WP-8x4x Release Notes

Hardware Revision:

CPU board Version

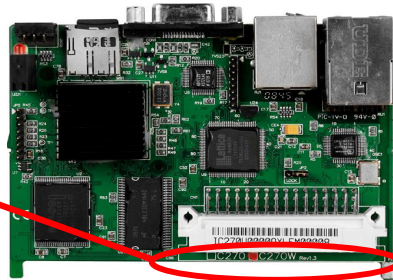
As the Intel 95ns and 75ns J3 Flash chip has been phased out, the chip in the WP-8x4x has been replaced with a 105ns version. However the new J3 Flash chip is not 100% compatible with the original one. Thus the OS and Eboot software for the WP-8x4x must be updated to version 1.5.0.1 (or later of the OS) and 1.2.0.1 (or later of the Eboot) to support both versions of the Flash chip. Version 1.5.0.2 fixes the problem that the 75ns J3 Flash chip is not able to run on OS version 1.5.0.1.

Also please note, older versions of the OS and Eboot software will not work on WP-8x4x modules that are equipped with the new J3 Flash chips, so earlier version of the OS and Eboot software should not be installed as the module will not boot.

CPU 板版本

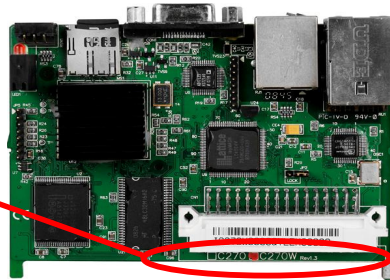
Intel 的 95ns 與 75ns J3 Flash Chip 已經停產，WP-8x4x 從 2010 年 4 月 6 日起，將使用另一個 105 ns 的 J3 Flash Chip 進行取代。但是這個新的 J3 Flash Chip 和原來的並不是 100% 相容，因此，必需將 OS 及 Eboot 更新到 1.5.0.1 及 1.2.0.1 版，以同時支援這兩種 J3 Flash Chip。1.5.0.2 版 OS 新增支援 75ns Flash Chip。

但是必需注意的是，舊版的 OS (1.4.2.1)及 Eboot (1.0.6.1)在配備新版 J3 Flash Chip 的 WP-8x4x 上將無法正常運作。請勿將舊版 Eboot 及 OS 安裝到配備新的 J3 Flash Chip 的 WP-8x4x 上，以免造成無法開機的問題。
